# UNITED STATES PATENT AND TRADEMARK OFFICE

10/594,181

<b>Office Action Summary</b>	<b>Application No.</b> 10/594,181	<b>Applicant(s)</b> BURTON ET AL.	
	<b>Examiner</b> JOSHUA T. KENNEDY	<b>Art Unit</b> 3679

## **DETAILED ACTION**

**Examiner's Figure**

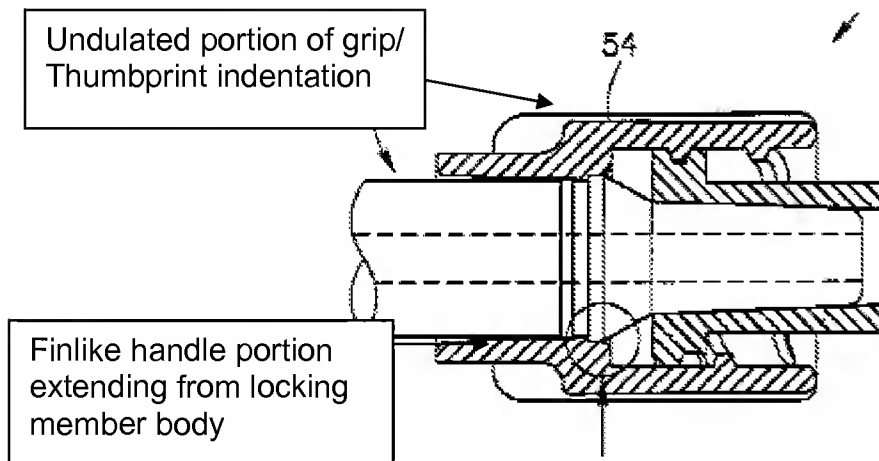
As to Claims 2, 3, 10, 17 and 18, Fitoussi et al disclose a luer fitting assembly wherein the locking member comprises a finlike handle and an undulating grip (see Examiner's Figure below).

As to Claims 4 and 19, as best understood Fitoussi et al disclose a luer fitting assembly wherein the locking member comprises a skeletal handle (see Examiner's Figure above; Examiner notes that there are no structural limitations defining what a skeletal handle comprises, and that applicant is merely naming the handle).

As to Claim 6, Fitoussi et al disclose a luer fitting assembly wherein the locking member comprises a cavity grip cavity grip having an indentation approximating the shape of a human thumbprint (see Examiner's figure above).

As to Claim 7, Fitoussi et al disclose a luer fitting assembly wherein the finlike handle radially extends outward from approximately one longitudinal end of the locking member (See Examiner's figure above).

As to Claim 9, Fitoussi et al disclose a luer fitting assembly wherein the locking member comprises both a skeletal handle and an undulating grip (See Examiner's Figure above).
